ZA3 PCB STACK UP

Quanta Computer Inc.		
PROJECT : ZA3		
Size	Document Number	Rev
	CLOCK GEN(CK505)	1A
Date:	Sunday, March 08, 2009	Sheet 3 of 34

Model	REV	DATE	CHANGE LIST	NOTE
ZA3	A1A	20090107	PAGE16 : Reverse C301 R322 U19 R323 R324 for SPK AMP Power	ECN Release
		20090112	PAGE23 : Change PJ1 P/N and Footprint	
		20090113	PAGE18 : Del RN20 and add RN21 RN22 for HDD issues	
			PAGE18 : Add R325 for JMH330 XTAL issues	
			PAGE21 : Change CN4 P/N from DFFC24FR023 to DFFC24FR017	
			PAGE21 : Change CN4 footprint	
			PAGE20 : Change CN5 P/N from DFFC14FR080 to DFFC14FR047	
			PAGE20 : Change CN6 P/N from DFFC12FR293 to DFFC12FR019	
			PAGE17 : Change CN2 P/N from DFFC12FR293 to DFFC12FR019	
			PAGE20 : Change CN5 footprint from BL121-14R-TAND-14P-L-BU1 to af714l-n2g1x-14p-l	
			PAGE19 : Change ESD1 value to U20	
			PAGE16 : Change CN7 P/N from DFHS04FS969 to DFHD04MRA75	
			PAGE16 : Change CN7 footprint from 88460-0401-4p-l to 88266-040xx-xxx-4p-l	
			PAGE4 : Change CN7 P/N from DFHS04FS969 to DFHD04MRA75	
			PAGE4 : Change CN7 footprint from 88460-0401-4p-l to 88266-040xx-xxx-4p-r

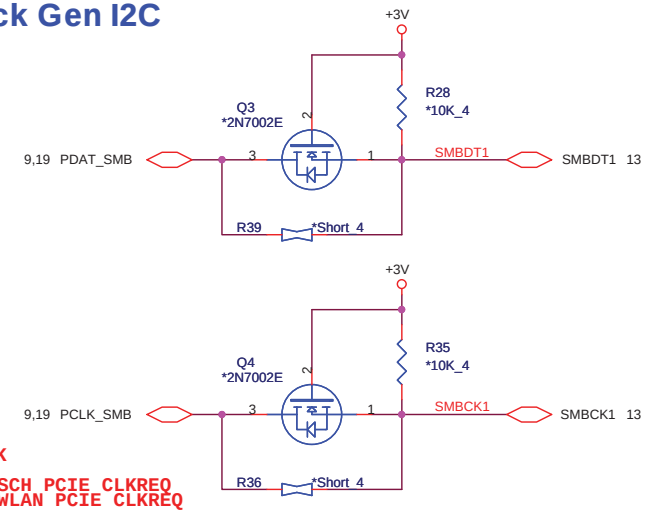
Change R43 P/N
from
CS00002JB38 to
CS31002JB28
rev.c 20090301

Size	Document Number	Rev
	Silverthorne CPU(01_HOST)	1A
Date:	Sunday, March 08, 2009	Sheet 4 of 34

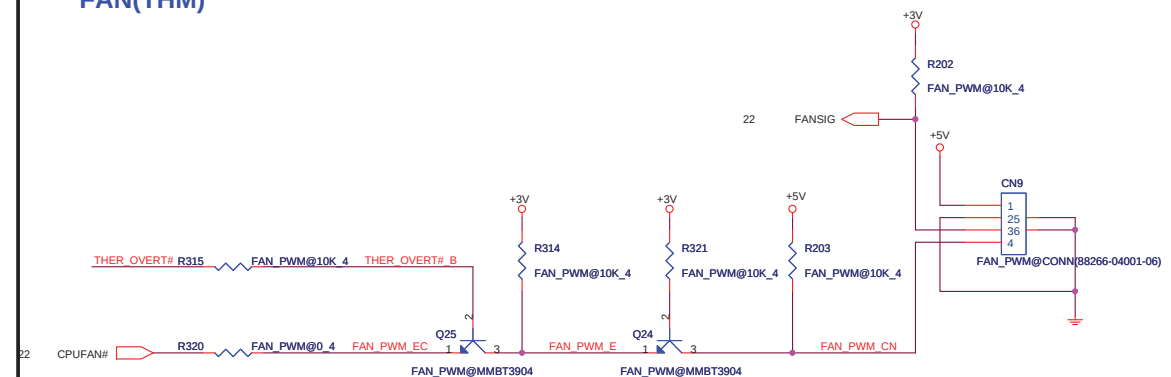
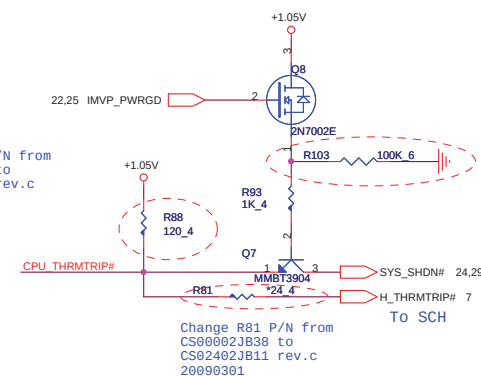
Note : H_FERR# for layout length must be greater than 150mils 20081128

For intel suggest R115 connect to +1.05V_C6_OFF 20081218

Modify JETC pins for Boundary
Scan rev.b 20090205

Change R88 P/N from
CS05602JB17 to
CS11202JB21 rev.c
20090301

Change R81 P/N from
CS00002JB38 to
CS02402JB11 rev.c
20090301

Size	Document Number	Rev
	Silverthorne CPU(03_Power)	1
Date:	Sunday, March 08, 2009	Sheet 6 of 34

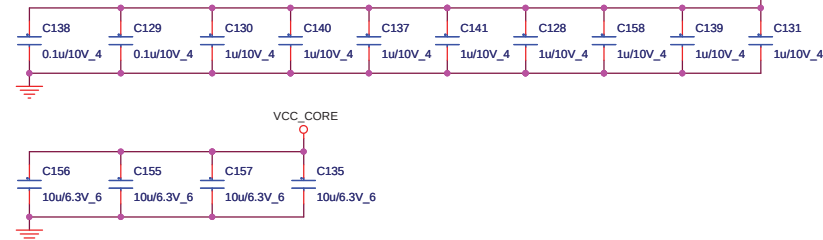
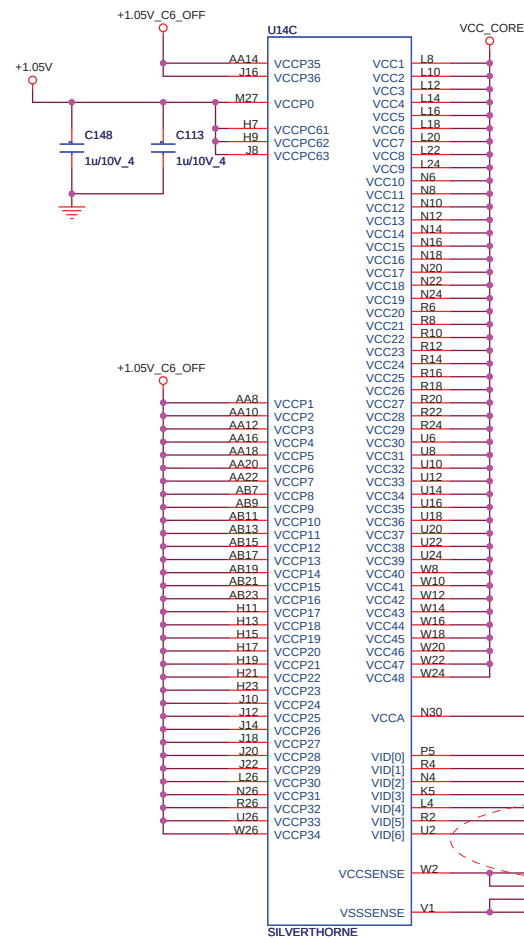
For Design Guide VCCSENSE pull up
100ohm to VCC_CORE 20081206

Modify +1.05V_C6_OFF
circuit 20090113

Modify R326 from
10K to 100K and
pull up +3V rev.c
20090228

Modify R168 P/N
from CS31002JB28
to CS41002JB20
rev.c 20090228

Add and reverse
Q27 R329 for C6
circuit rev.c
20090303

Size	Document Number	Rev
	Poulsbo(03 USB/PATA/HD)	1A
Date	Sunday March 08, 2009	Sheet 9 of 34

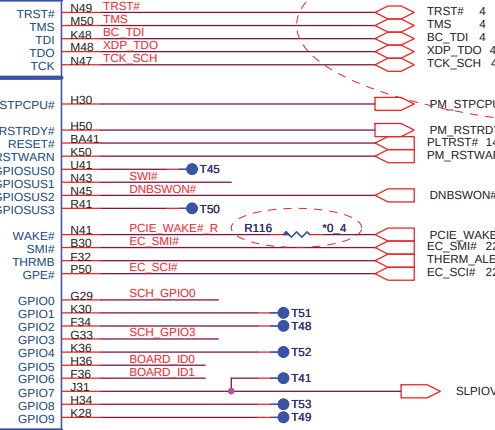
Modify JETC pins for Boundary Scan rev.b 20090205

Change R297 from +3V_S5 to +3V for SMI# rev.c 20090304

For intel suggest add R295 pull down 20081218

SDVO To CRT(CRT)

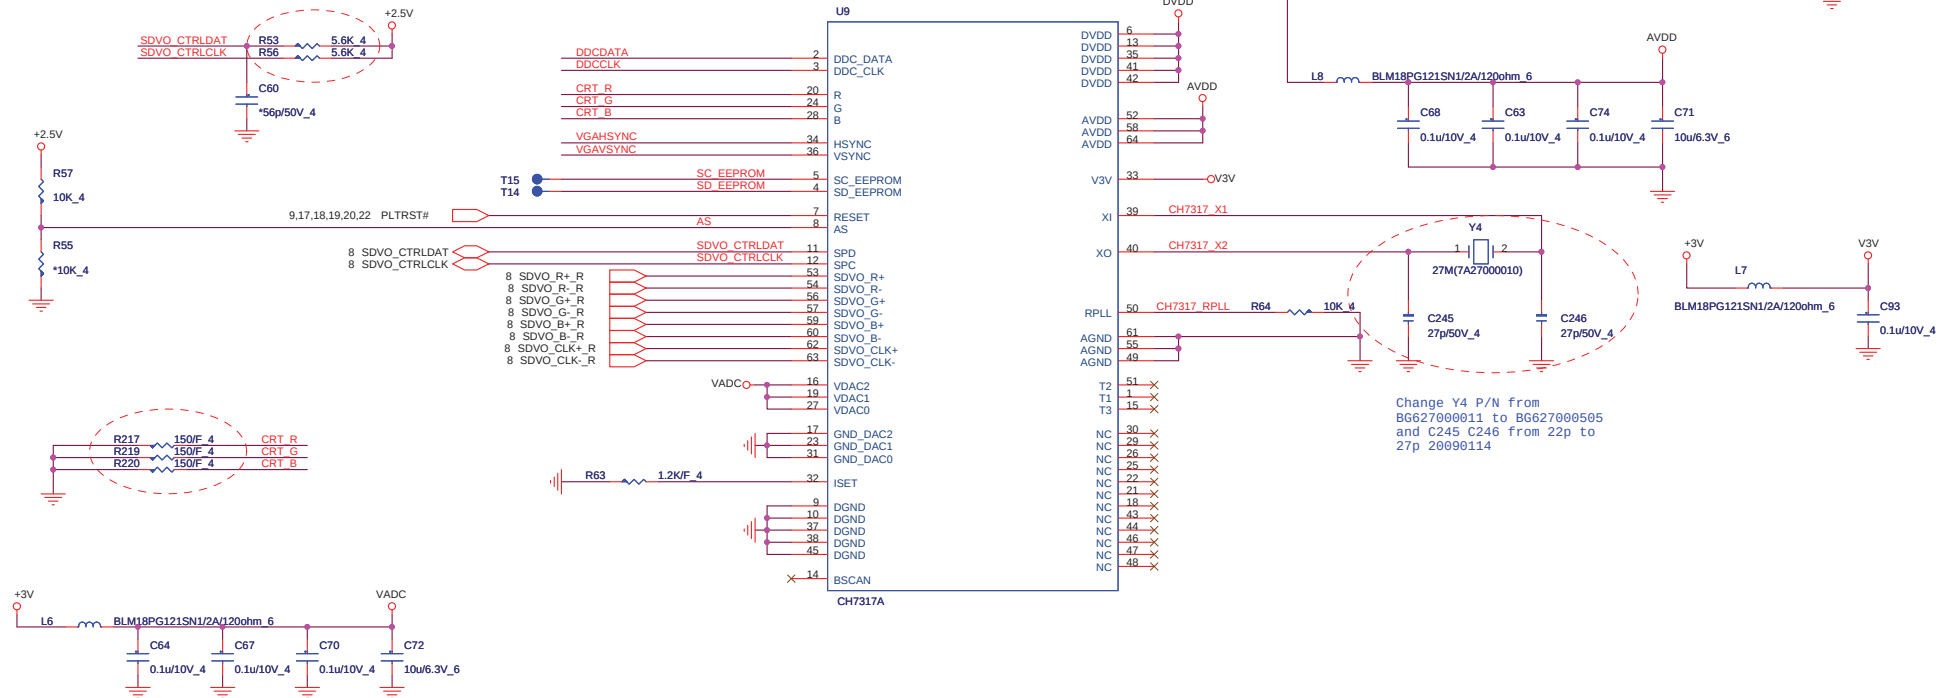
For vender FAE check, Change R53
R56 from 3.9K to 5.6K 20081205

Size: Document Number
USB/SD_LED AND CR_USB DB
Date: Sunday, March 08, 2009 Sheet 20 of 34 Rev 1A

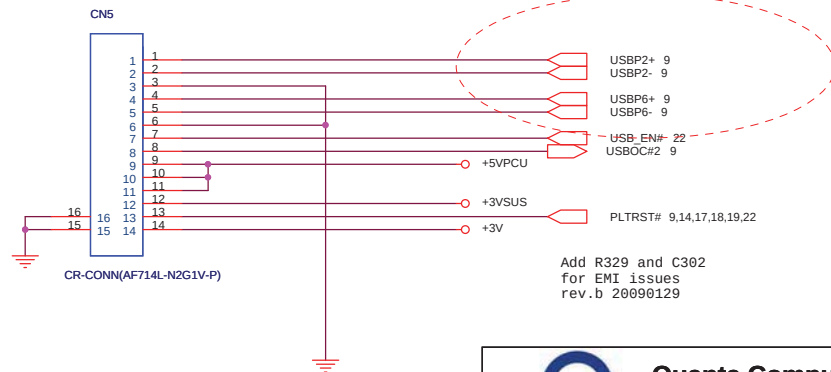
Add R329 and C302
for EMI issues
rev.b 20090129

BT CONNECTER(BTM)

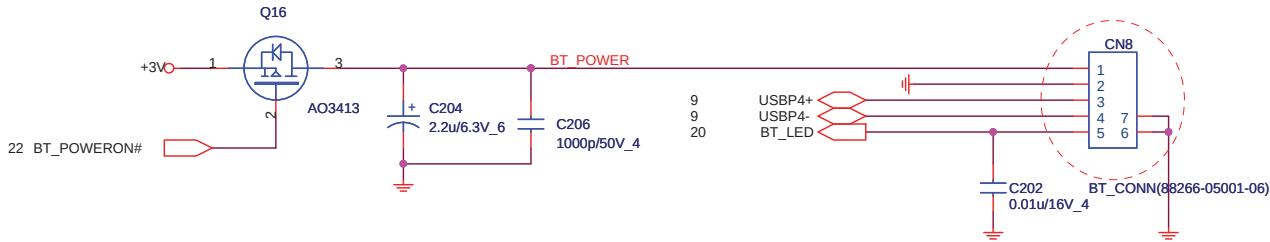
Modify CN8 footprint and pin define rev.c 20090301

Size	Document Number	Rev
	HOLE	1A
Date: Sunday, March 08, 2009	Sheet 30 of 34

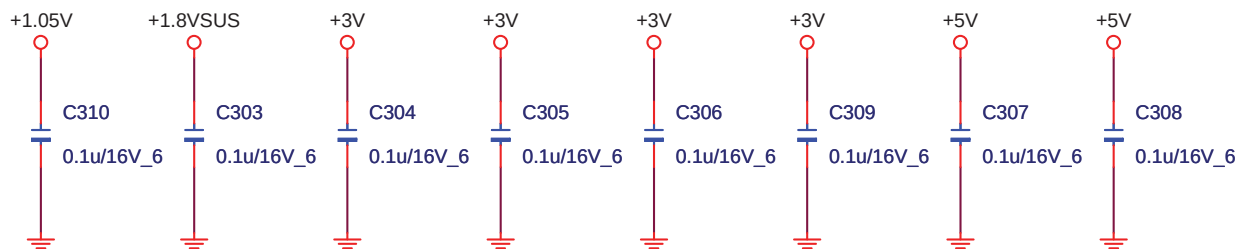
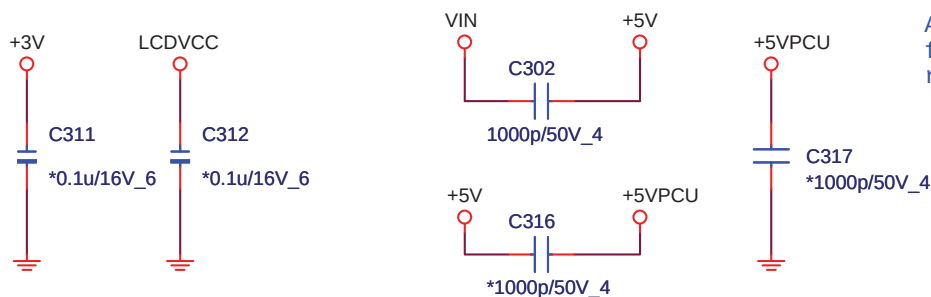
Add C303 C304 C305 C306 C307
C308 for EMI request rev.b
20090206 Add C309 C310 for
EMI request rev.b 20090207

Add C302 C316 C317
for EMI issues
rev.c 20090303
